Request
Project Name
Case Number
Council District
Requested by

DTC Modification
Nashville Yards Parcels 2 & 3
2018DTC-014-001
19 – O’Connell
Ragan-Smith Associates, Inc., applicant; Uptown Property Holdings, LLC, owner

Downtown Code DRC Meeting of 9/6/2018

Figure 1: Nashville Yards Development Plan Parcels

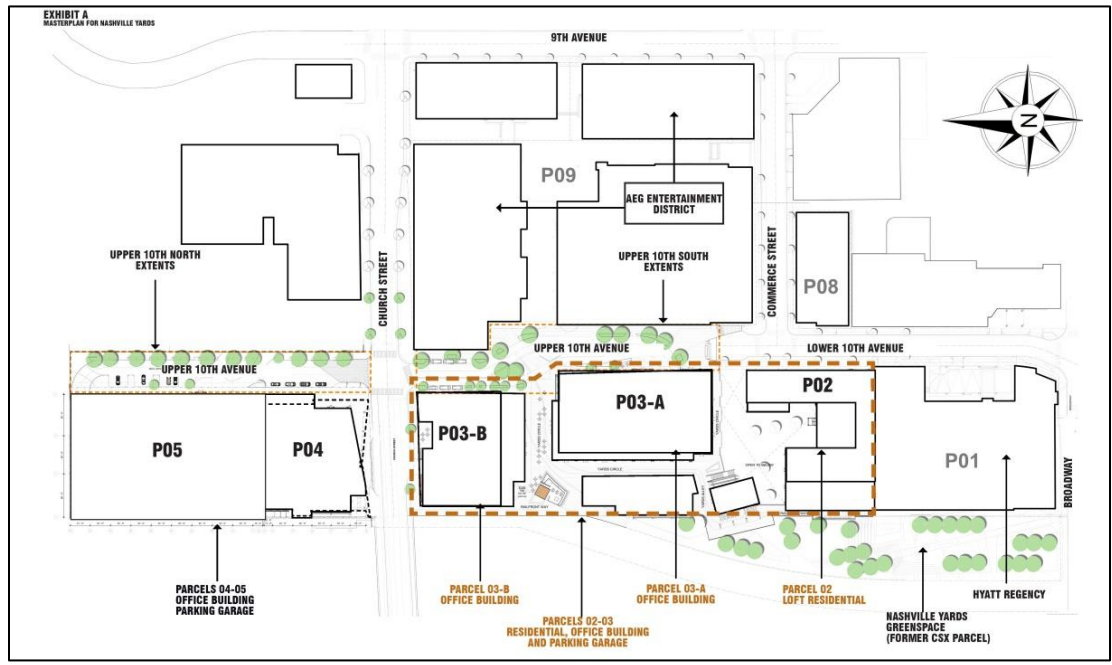
The DTC requires both measurements from grade and measurements of height to be calculated from the average elevation from the public sidewalk. Building P03-B, as shown in Figure 1, is adjacent to Church Street as well as both Upper and Lower 10th Avenue North and Building P03-A is adjacent to both Upper and Lower 10th Avenue North. These standards do not anticipate this atypical situation where multiple streets front the same façade at different grades. The modification would allow all measurements from grade and of height to be taken from Upper 10th Street, which has active ground floor uses. The DTC emphasizes the relationship between buildings and the public realm and allowing these measurements to be calculated from the active ground floor elevation is consistent with this intent.

The residential building (shown as P02 on Figure 1) is proposing floors 2 through 17 of the hotel tower to have a 9'-8" floor to floor height, where 10' is the DTC minimum height. The top three floors have a height of 12'-8" The difference of 4" over 15 floors is relatively minor and only results in a 5' reduction to the height of the overall building. The 10' upper floor height requirement is intended to prevent short and squat buildings, and for the possible transition of commercial buildings to multiple potential users over time. However, hotel and residential uses are adequately served by 9'-8" floor to floor heights.

Figure 4: Upper and Lower 10th Avenue South, Facing West

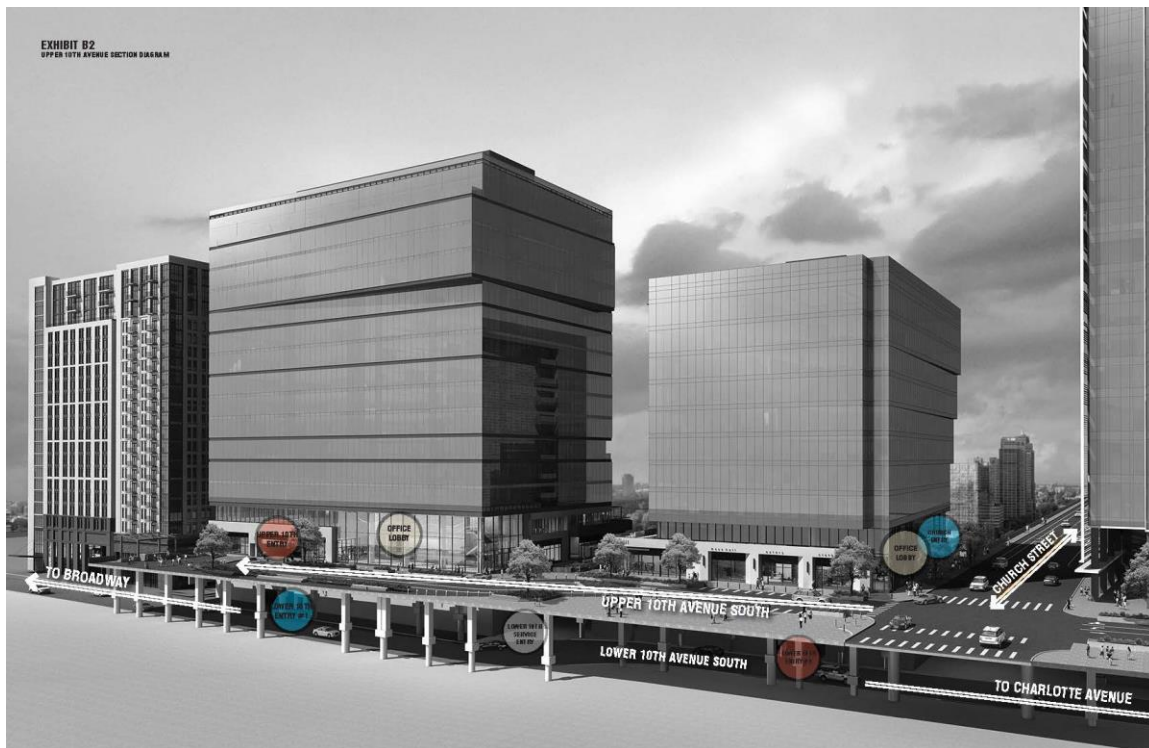
Figure 4, shown below, illustrates how Upper 10th Avenue North fits into the other components of the proposal. Although there is no direct vehicular connection between Upper and Lower 10th Avenue North, the site plan does allow for pedestrian circulation between the two levels via the pedestrian corridor connecting the various components of the site.

Due to the unique configuration of Upper and Lower 10th Avenues, the project is proposed to have active ground floor uses on Upper 10th Avenue and Church Street and not on Lower 10th Avenue. The project proposes using the frontage on Lower 10th Avenue for back-of-house operations, including parking structure entrances and loading areas. The frontages proposed also do not strictly meet the Core subdistrict standard of a 0'-10' build-to zone with an 80% minimum façade width along the 10th Avenue North ground floor and the Church Street ground floor.

Figure 7: Broadway Planters

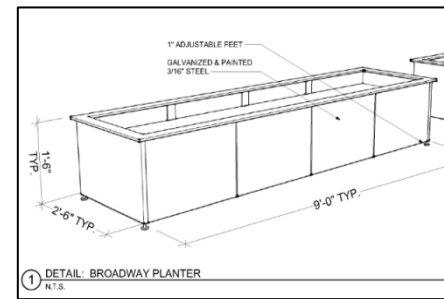
The design team for this project has also requested to omit street trees along two frontages: Lower 10th Avenue and Church Street. Lower 10th Avenue is not an ideal location for street trees, as access to natural light will be limited by the presence of Upper 10th Avenue. At this location, Church Street is an elevated viaduct with no existing planting strips or tree grates, making adding street trees infeasible. In addition, omitting already infeasible street trees along this frontage will allow for the addition of an off-street north-south bicycle facility. The DTC emphasizes the sidewalk corridor as a vital part of the urban character of every neighborhood and identifies pedestrian paths, landscaped planters, street furnishings, and street trees as elements that contribute to that character. Parcel 1 of the Nashville Yards development faced a similar challenge along the Broadway viaduct and proposed 2.5' x 9' planters with perennials in lieu of street trees, as shown in Figure 7. Due to the site conditions, planning staff is in support of this request, but is recommending that similar planters be used along the Church Street frontage.

1. Add planters along the Church Street façade to mitigate the omission of street trees, staff to review prior to final site plan approval.

Figure 9: Proposed Park

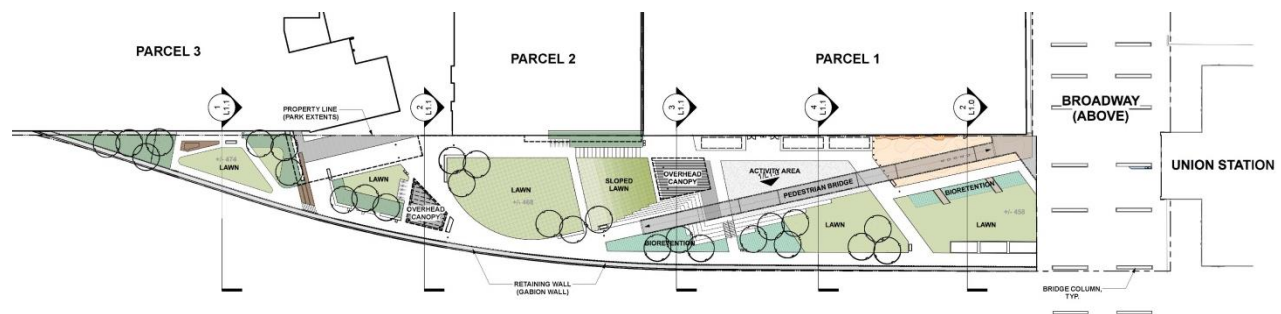
The DTC also emphasizes the need for high-quality open spaces in Downtown and the park feature is being proposed in an area with an open space deficiency, as identified by the Open Space Plan of the DTC. However the proposed park does not fit strictly within any one category of open space identified by the DTC: greens, squares, plazas, courts, pocket parks and playgrounds. Instead, the proposal incorporates both structured and unstructured open space, as well as green space. The unusual shape of the parcel, adjacency to the CSX rail lines, and grade change create significant design challenges to the site. Although the open space is intended to be accessed by the public, it is not proposed to be dedicated to the public, nor will it have a public access easement. However, the open space is also not being provided to achieve additional height through the Bonus Height Program (BHP). The open space is unique and well-designed, allowing direct pedestrian access from Broadway into the activated paseo area. Planning is in support of this proposed open space.
